SUBJECT: Contract 008066  
SR 520, Floating Bridge and Landings Project  
Federal Aid No. BR-0520(047)  
**Change Order No. 123 – Urban Design Belvederes**

**WASHINGTON STATE  
DEPARTMENT OF TRANSPORTATION  
CHANGE ORDER**

CONTRACT NO: 008066 FEDERAL AID NO: BR-0520 (047)  
 CONTRACT TITLE: SR 520 / I-5 TO MEDINA - EVERGREEN POINT FLOATING  
 CHANGE ORDER NO: 123 URBAN DGN - BELVEDERES  
 PRIME CONTRACTOR: SW0106139 KIEWIT/GENERAL/MANSON, A JOINT  
 33455 6TH AVE S  
 FEDERAL WAY WA 98003-6335

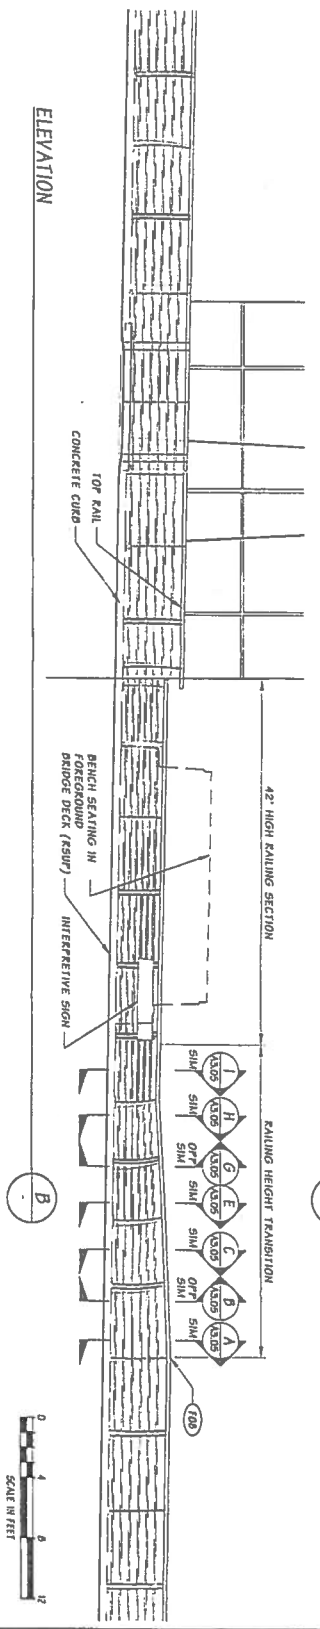
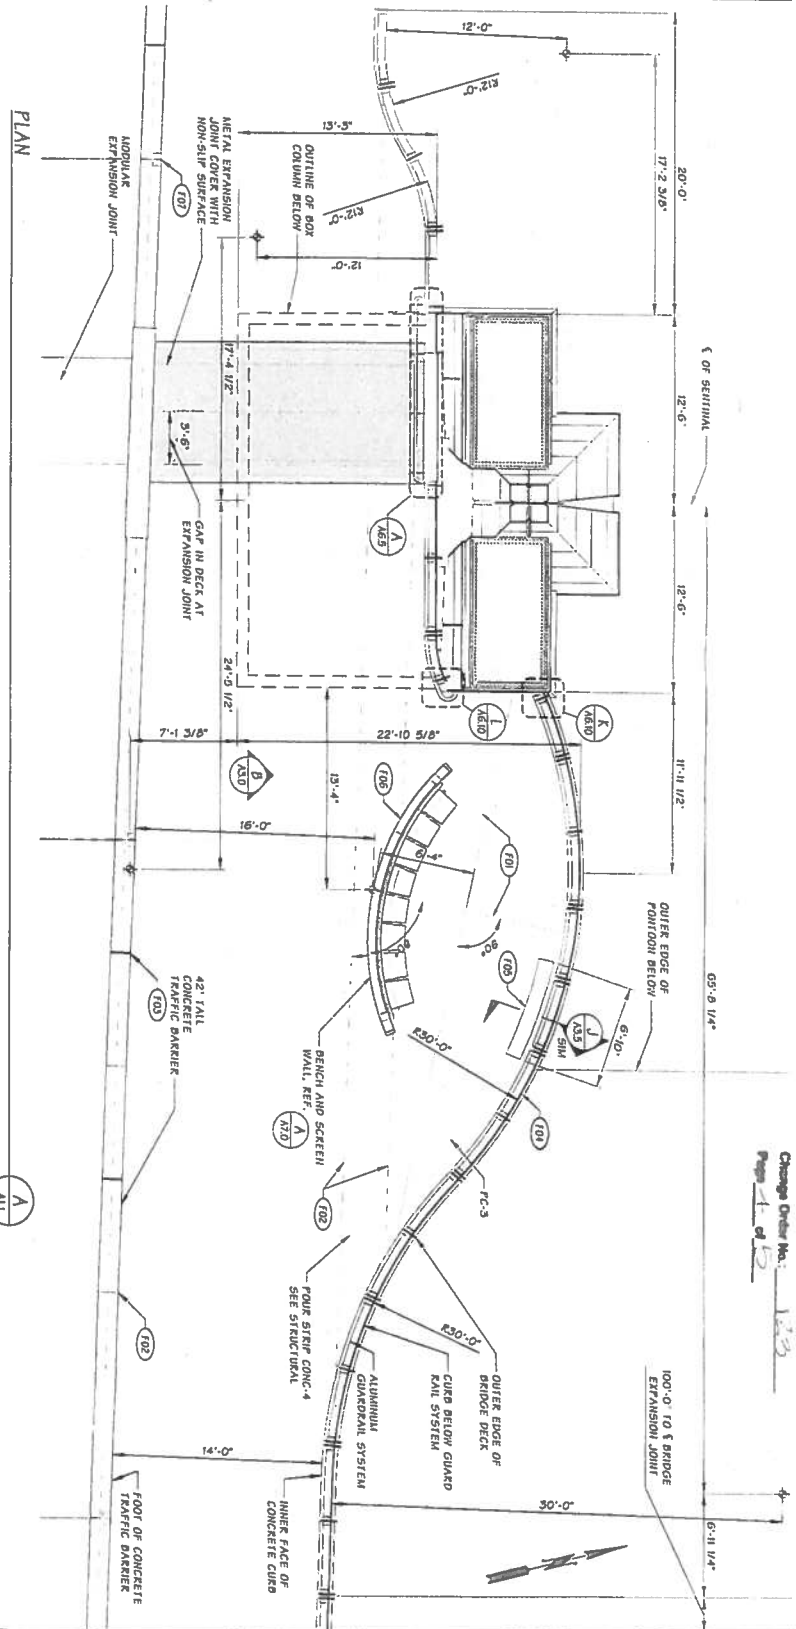
"Each belvedere at the sentinel elements shall be a minimum of 500 square feet, and each shall be located to only one side of the sentinel element as shown on sheets 4 and 5 of 5 of this change order. Each belvedere on the flat portion of the floating bridge shall be a minimum of 210 square feet. All belvederes shall be located clear of the RSUP."
